PLANT NAME:
Oconee 1-2-3

Amdt. to ol/change to tech spec consisting of
request to revise the flux/flow trip setpoint
for unit 1 as well as incorporating a
surveillance testing requirement for the
internals vent valves.

Re: Oconee Nuclear Station
Docket Nos. 50-269, -270, and -287

Pursuant to 10CFR50, §50.90, Duke Power Company hereby requests a change in the Oconee Nuclear Station Technical Specifications. The proposed change consists of revising the flux/flow trip setpoint for Oconee Unit 1 as well as incorporating a surveillance testing requirement for the internals vent valves.

UNIT 1
 CORE PROTECTION SAFETY LIMIT
 OCONEE NUCLEAR STATION
 FIGURE 2.1-2A

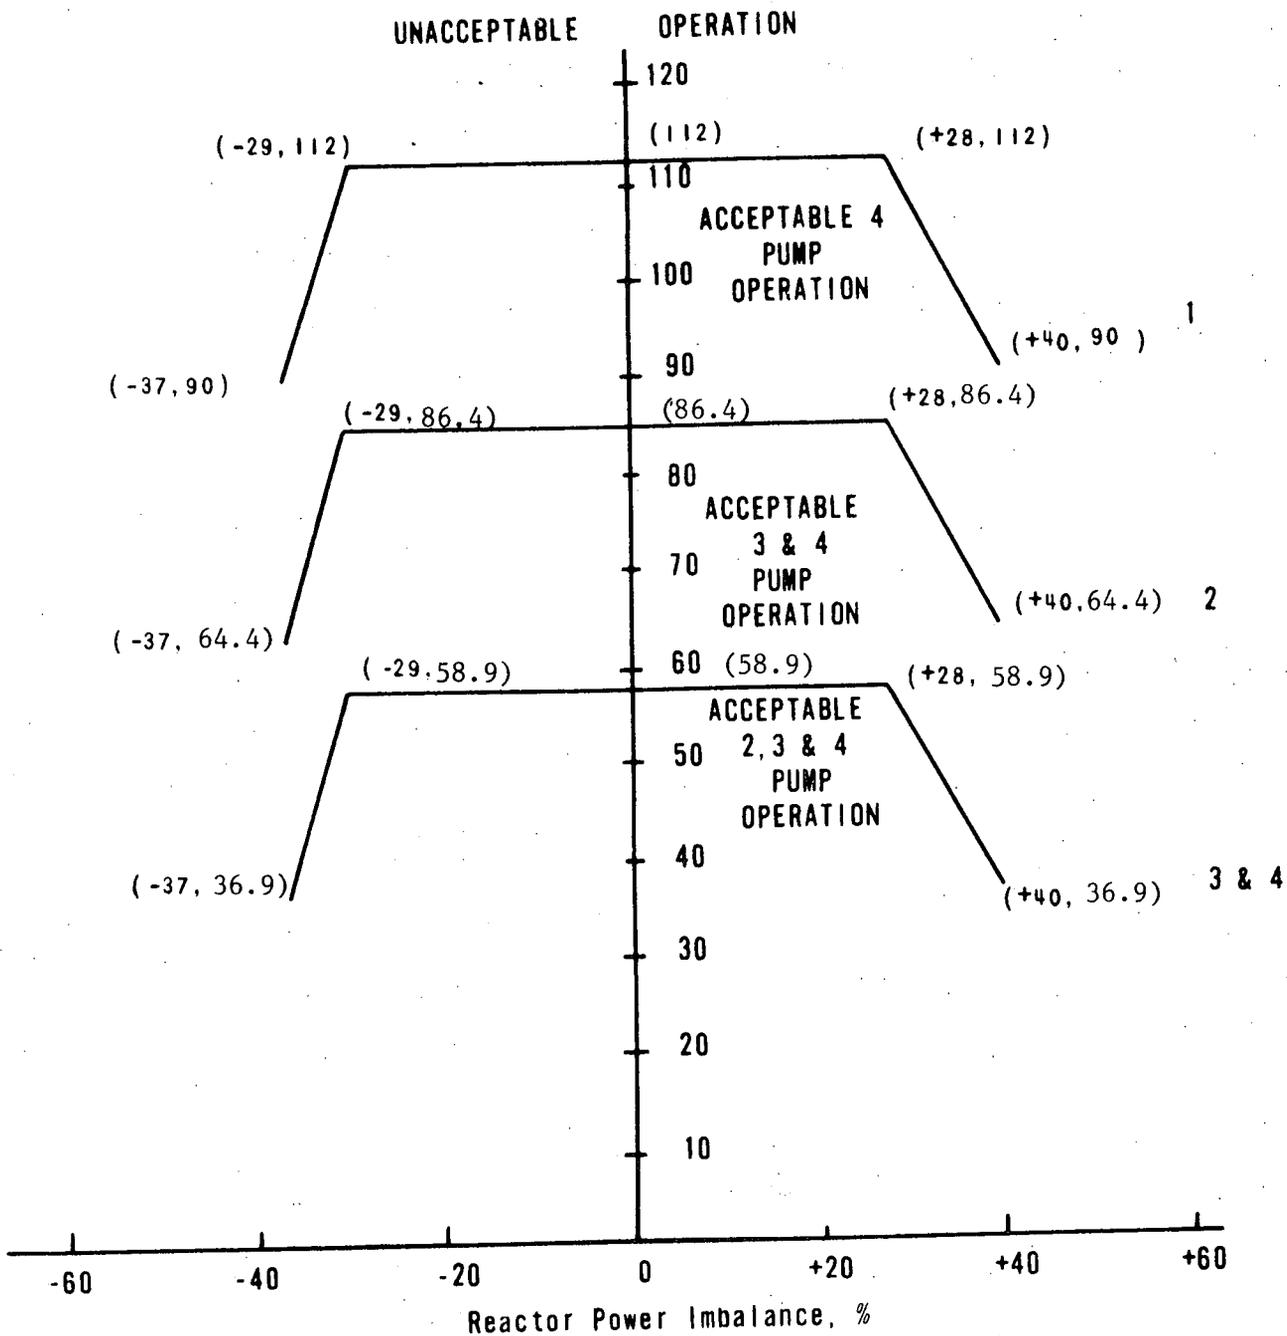
The curves of Figure 2.1-2A are based on the more restrictive of two thermal limits and include the effects of potential fuel densification and rod bowing:

1. The 1.30 DNBR limit produced by the combination of the radial peak, axial peak and position of the axial peak that yields no less than a 1.30 DNBR.
2. The combination of radial and axial peak that causes central fuel melting at the hot spot. The limit is 20.15 kw/ft for Unit 1.

The specified flow rates for Curves 1, 2, 3 and 4 of Figure 2.1-2A correspond to the expected minimum flow rates with four pumps, three pumps, one pump in each loop and two pumps in one loop, respectively.

The maximum thermal power for three-pump operation is 86.4 percent due to a power level trip produced by the flux-flow ratio 74.7 percent flow \times 1.07 = 79.9 percent power plus the maximum calibration and instrument error. The maximum thermal power for other coolant pump conditions are produced in a similar manner.

CURVE	REACTOR COOLANT FLOW (lb/hr)
1	141.3 x 10 ⁶
2	105.6 x 10 ⁶
3	69.3 x 10 ⁶
4	64.7 x 10 ⁶

FIGURE 2.3-2A

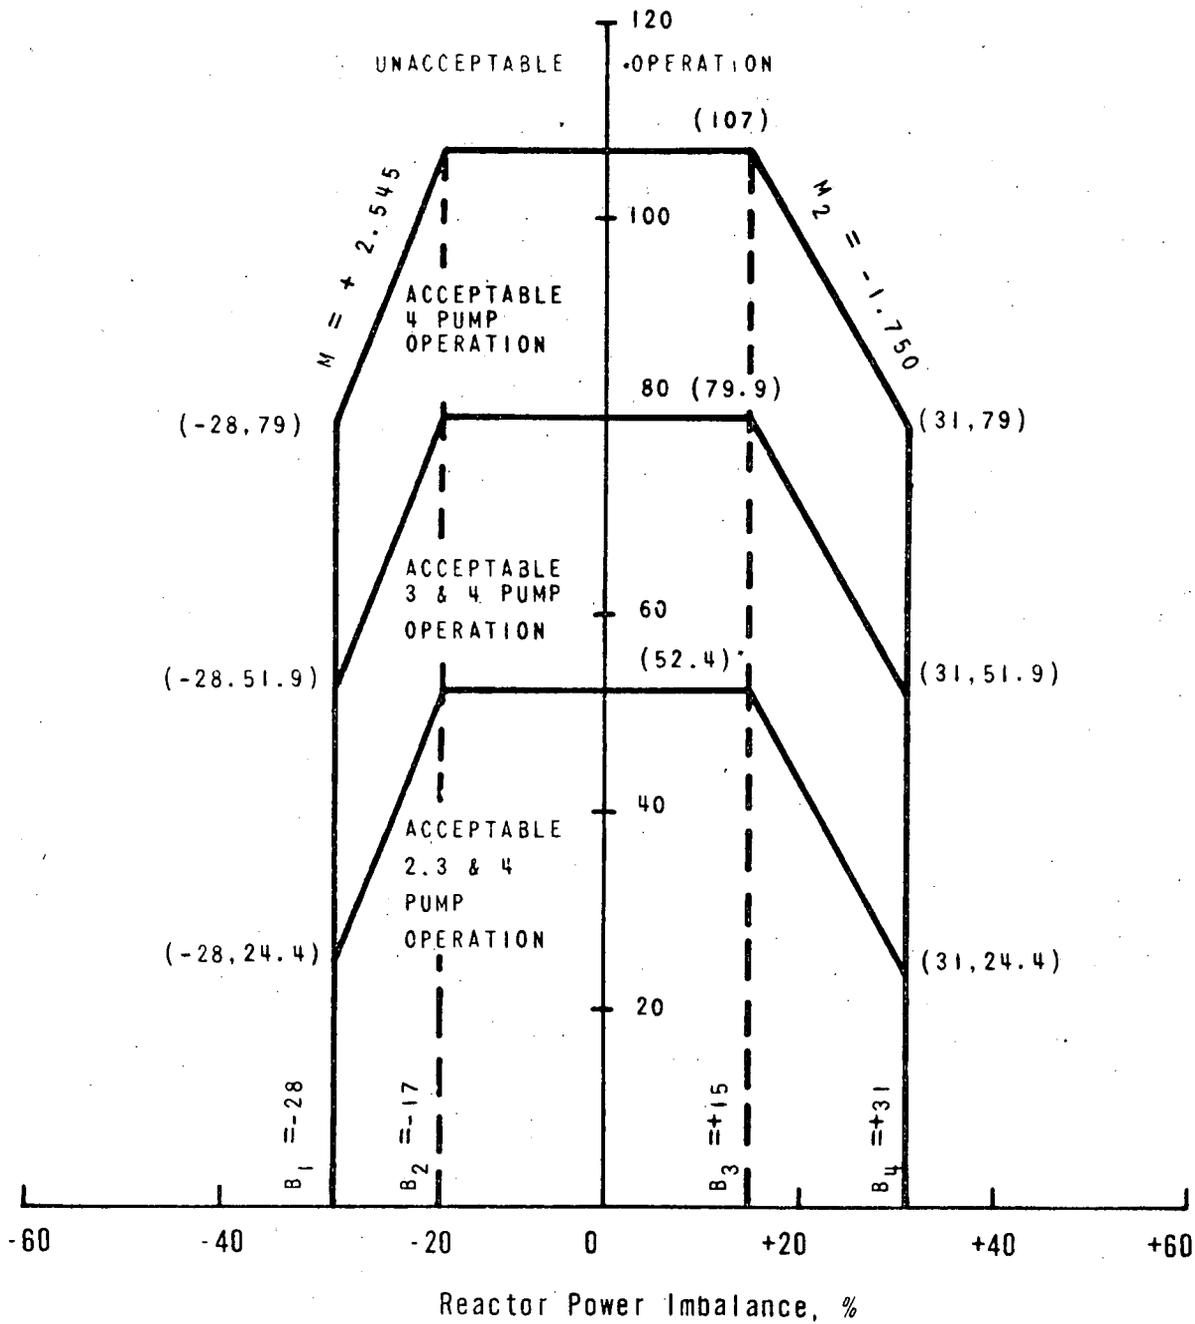
The power-imbalance boundaries are established in order to prevent reactor thermal limits from being exceeded. These thermal limits are either power peaking kw/ft limits or DNBR limits. The reactor power imbalance (power in the top half of core minus power in the bottom half of core) reduces the power level trip produced by the power-to-flow ratio such that the boundaries of Figure 2.3-2A - Unit 1 are produced. The power-to-flow ratio reduces the power:

level trip and associated reactor power/reactor power-imbalance boundaries by 1.07% for a 1% flow reduction.
